South Coast Air Quality Management District
21865 Copley Drive, Diamond Bar, CA 91765-4182
(909) 396-2000 • www.aqmd.gov

February 1, 2012

Draft Environmental Impact Report
Southern California International Gateway (SCIG) Project

Attachment A
Additional Comments on the DEIR for
Southern California International Gateway (SCIG) Project

Figure 1: Surrounding Residential and Sensitive Land Uses Near Proposed SCIG Facility

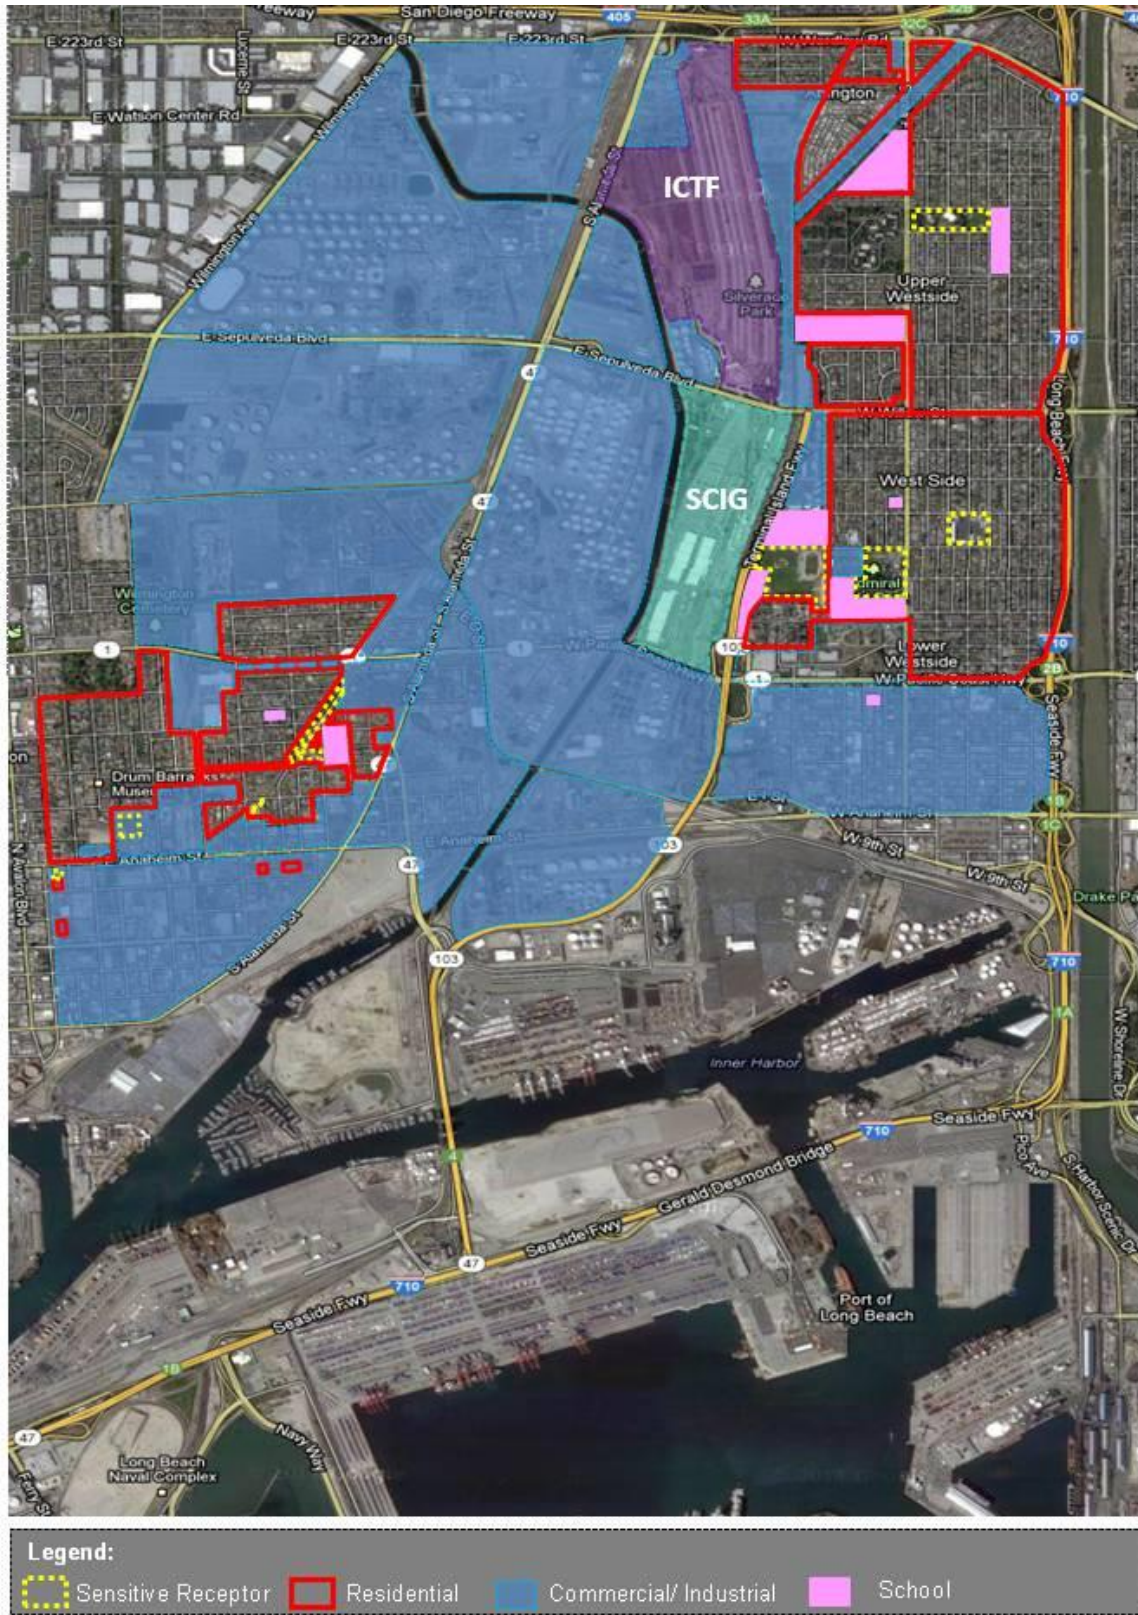
The proposed SCIG project will be one of the largest intermodal railyards in the United States and will be located near residences, schools, a pre-school, and a veterans center. The West Side neighborhood of Long Beach is home to approximately 13,500 residents⁴ and lies between the project site and the I-710 freeway, but as close as 1,000 feet from the proposed project. In addition, Hudson School, an elementary and middle school with over 1,000 students, is less than 600 feet from the eastern boundary of the proposed Project site⁵. The Mary Bethune School and Cabrillo Child Development Center are less than 500 feet from the eastern boundary of the proposed site. See Figure 1.

Figure 2: 1-Hour NO₂ Unmitigated Impacts

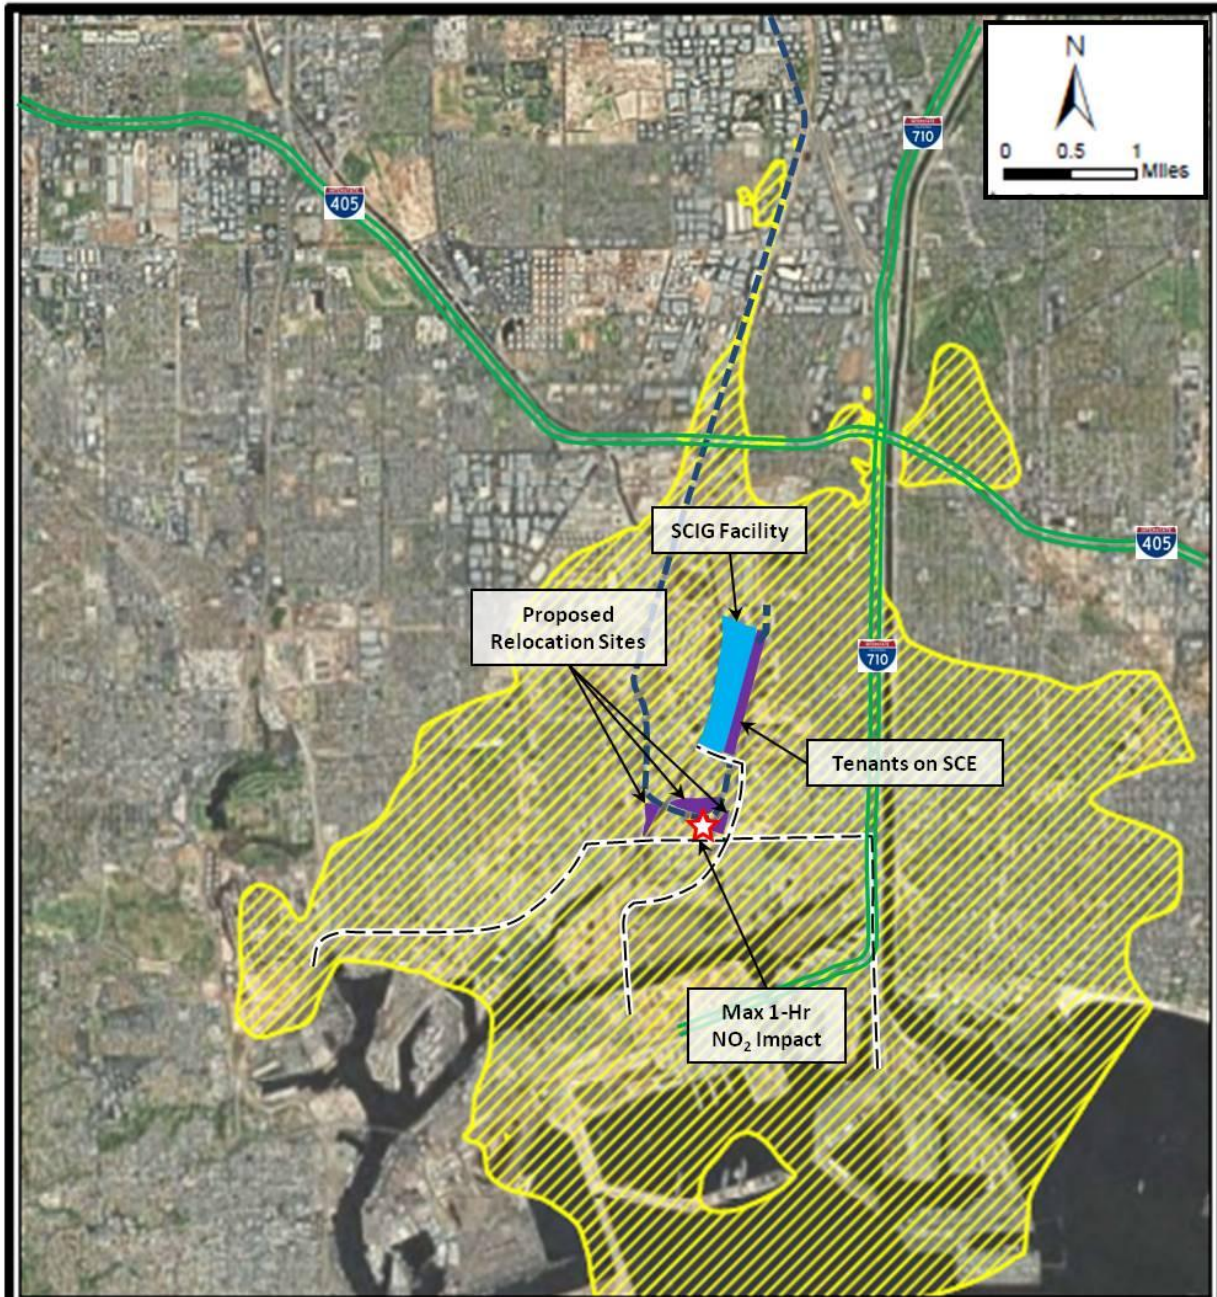
The Proposed SCIG Project will result in significant localized impacts of NO₂ and PM₁₀. As depicted in Figure 2 below, NO₂ is expected to exceed federal standards over a wide area, including population centers in west Long Beach and Wilmington. Concentrations of NO₂ in the community from the project alone are predicted to exceed the federal standard by at least a factor of five (Table 1 below). The modeled point of maximum NO₂ impact is located adjacent to the relocated tenants south of the project site. PM₁₀ impacts are predicted to exceed the annual and 24-hour SCAQMD Air Quality Significance Threshold by a factor of about 20. The area of PM₁₀ impact also extends into the west Long Beach community adjacent to the SCIG facility (Figure 3 below).
